Access Compliance Report

Public Rights-of-Way

Intersection ID: 27190	Main Street: BALLANTYNE COMMONS PY	Cross Street: WOODVIEW CR	Location: SW
ADA ID: 8EAC8238A1A0	Ramp Type: Perpendicular Diagonal	Initial Pass/Fail: Fail	Overall Compliance: No
Severity Score: 12.5			
Codes/Mitigation Info/Possible Solution		Field Measurements/Component Compliance

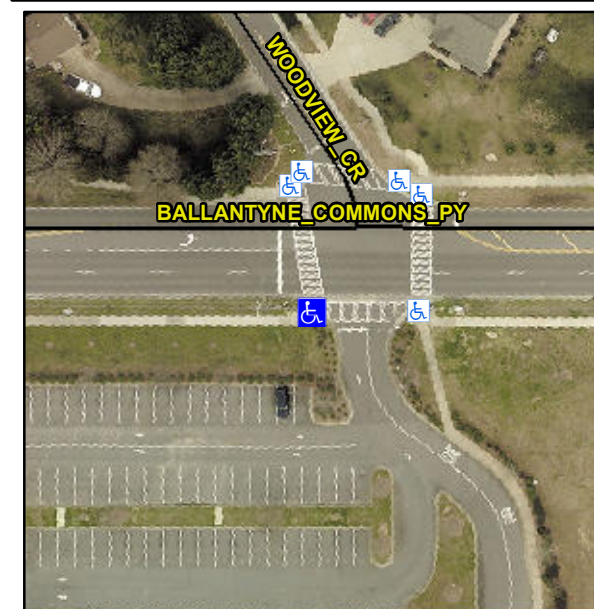
Not Found, R304.2.2

Compliance	Description	Data	Compliance	Description	Data
N/A	Ramp Length (in)	95.0	No	Ramp Slope (%)	8.7
Yes	Ramp Width (in)	49.0	Yes	Ramp XSlope (%)	0.9
N/A	Flare Type LT	N/A	N/A	Flare Type RT	N/A
N/A	Flare Slope LT (%)	N/A	N/A	Flare Slope RT (%)	N/A
N/A	Flare Traversable LT?	N/A	N/A	Flare Traversable RT?	N/A
N/A	Landing Length (in)	N/A	N/A	DWS Provided?	N/A
N/A	Landing Width (in)	N/A	N/A	DWS Contrast?	N/A
N/A	Landing Slope (%)	N/A	N/A	DWS Length (in)	N/A
N/A	Landing X Slope (%)	N/A	N/A	DWS Full Width?	N/A
N/A	Landing Curb? (Y/N)	N/A	N/A	DWS Offset (in)	N/A
N/A	Shared Landing?	N/A			
N/A	Gutter Ponding?	N/A	N/A	Gutter Slope (%)	N/A
N/A	Gutter Lip Ht (in)	N/A	N/A	Gutter X Slope (%)	N/A
N/A	Painted X Walk1?	Yes	N/A	Painted X Walk2?	Yes
	X Walk 1 Direction	To E		X Walk 2 Direction	To N
N/A	X Walk 1 Width (in)	105.0	N/A	X Walk 2 Width (in)	112.0
	X Walk 1 Slope (%)	3.7		X Walk 2 Slope (%)	3.8
	X Walk 1 X Slope (%)	5.3		X Walk 2 X Slope (%)	1.2

Remove & Replace Curb Ramp With Two New Directional Ramps or Equivalent.
